**Amendments to the Drawings:**

## **REMARKS/ARGUMENTS**

### **Drawings**

Figure 20A

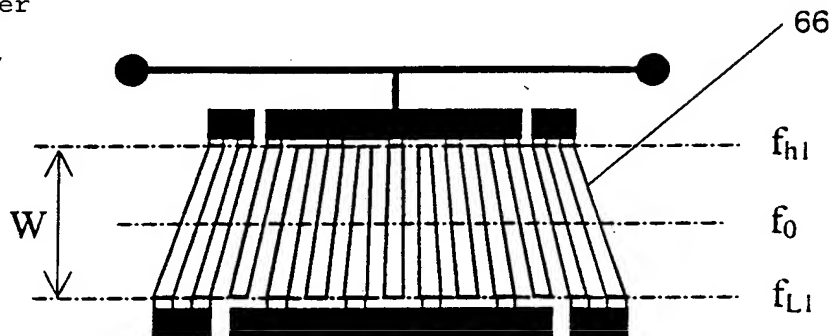
Figure Number  
Changed  
From "21A"  
To "20A"

Figure 20B

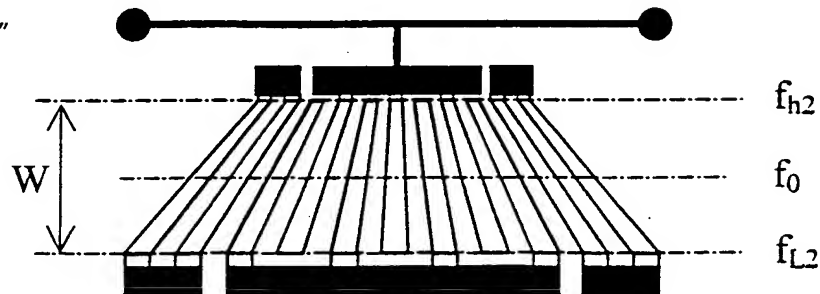
Figure Number  
Changed  
From "21B"  
To "20B"

Figure 20C

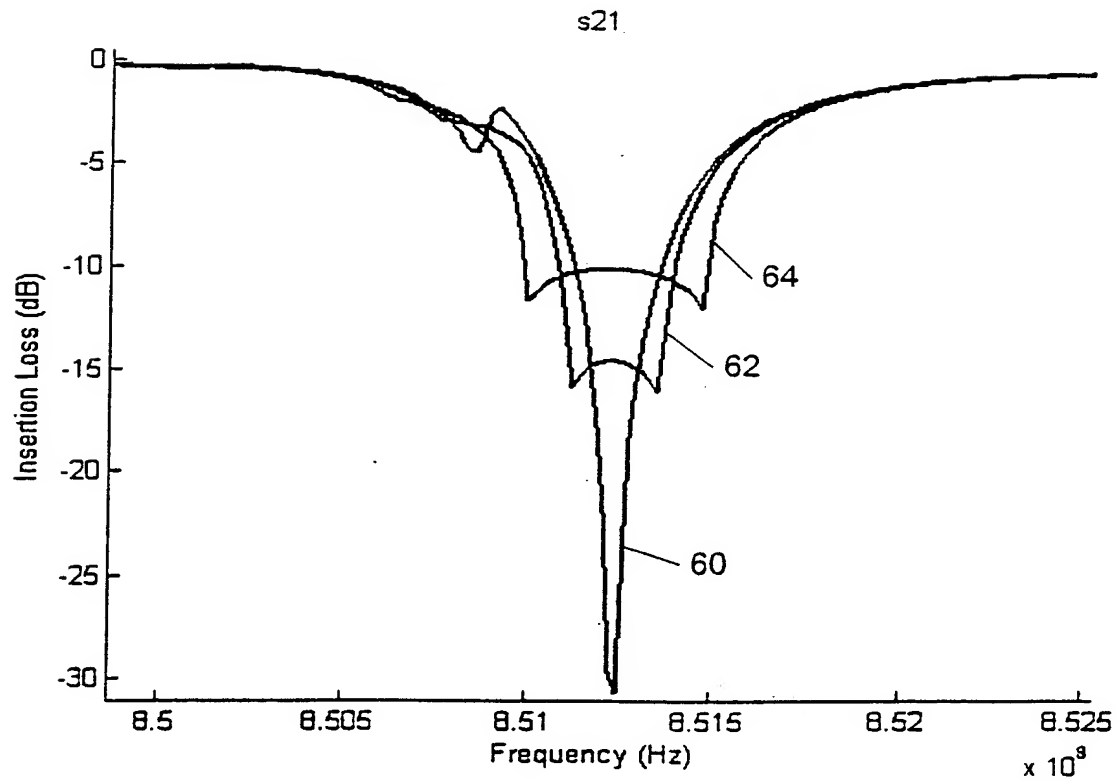
Figure Number  
Changed  
From "21C"  
To "20C"

Figure 21

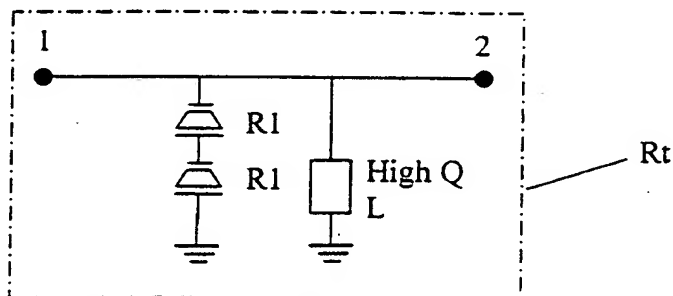
Figure Number  
Changed  
From "22"  
To "21"

Figure 22

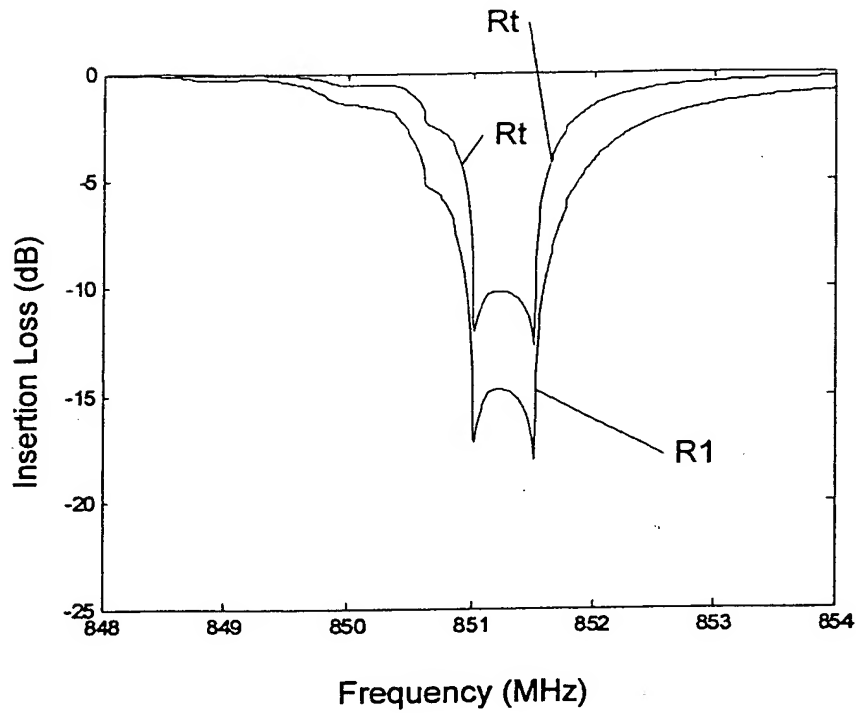
Figure Number  
Changed  
From "23"  
To "22"

Figure 23

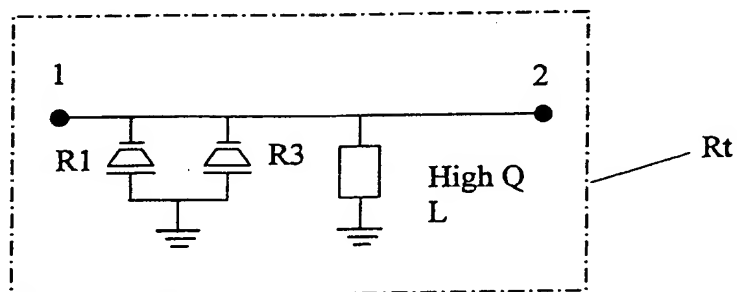
Figure Number  
Changed  
From "24"  
To "23"

Figure 24

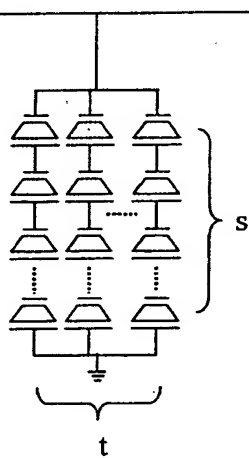
Figure Number  
Changed  
From "25"  
To "24"

Figure 26A

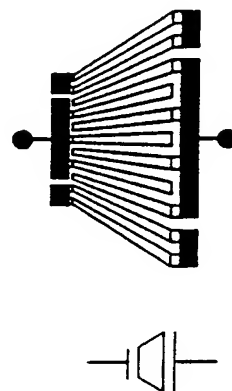
Figure Number Changed From "27A" To "26A"
